**DRAFT CORRIGENDUM TO SUPPLEMENT __ TO THE 04 SERIES
OF AMENDMENTS TO REGULATION No. 16 (Safety belts)**

A. PROPOSAL

Figure 1: Strap extraction when test acceleration has been reached after acceleration onset phase.

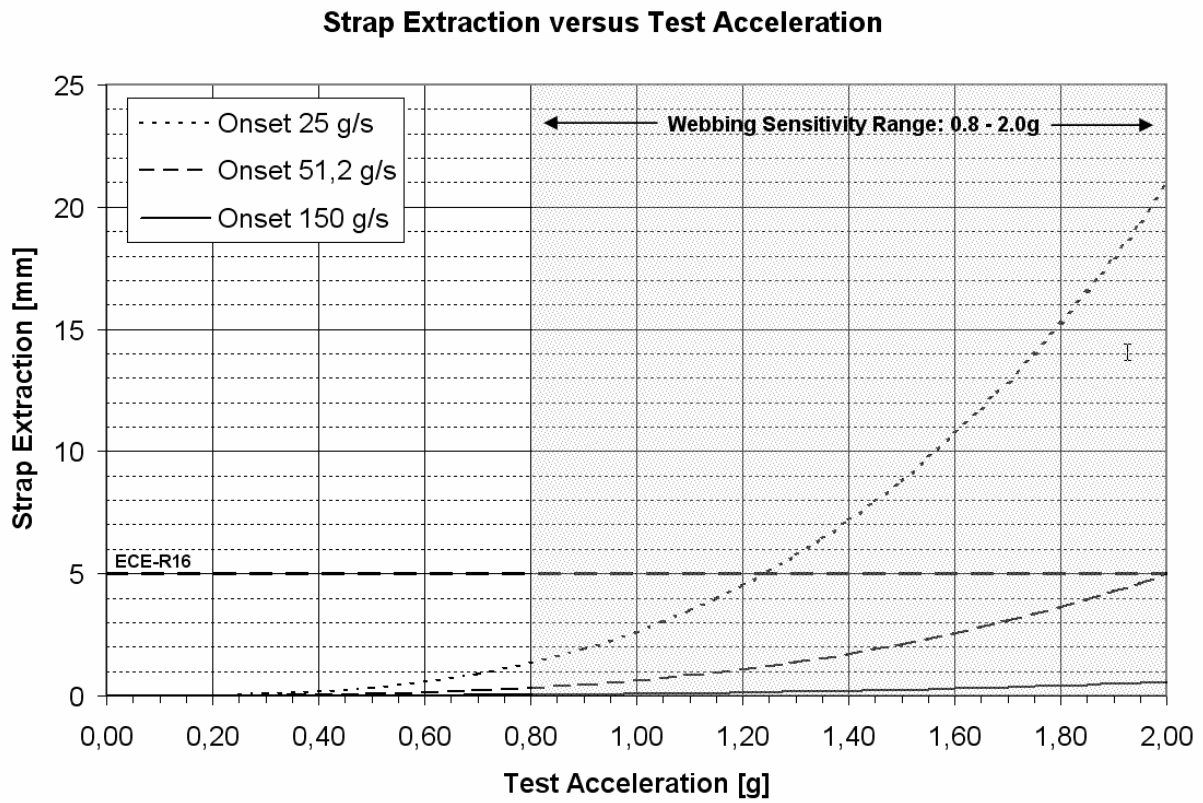
By applying the lower threshold of 25g/s and a test acceleration of 2.0g, which is the upper limit of the available locking range for webbing sensitive locking (0.8 – 2.0g see section 6.2.5.3.1.2 and 6.2.5.3.2), the resulting webbing extraction leads to $s = 20,9\text{mm}$ and to a violation of the requested 5mm.

In order to fully comply with the requested maximum 5mm in testing the sensitivity for strap movement the minimum average onset rate yields

$$\dot{a} > 51\text{g/s}.$$

For further clarification Figure 1 shows the resulting strap extraction as a function of the test acceleration for different onset rates.

The recommendation is to clarify the section 7.6.2.2 by differentiation into requirements for tests on the sensitivity for strap movement (upper limit 2.0g) and for tests on sensitivity for vehicle deceleration (upper limit 0.45g):

For the tests on the sensitivity on vehicle deceleration a range of 25-150g/s is still reasonable and a violation of the 5mm rule is not possible.

For the tests on the sensitivity tests on strap movement an onset rate range of 55-150g/s is recommended to avoid conflicts.
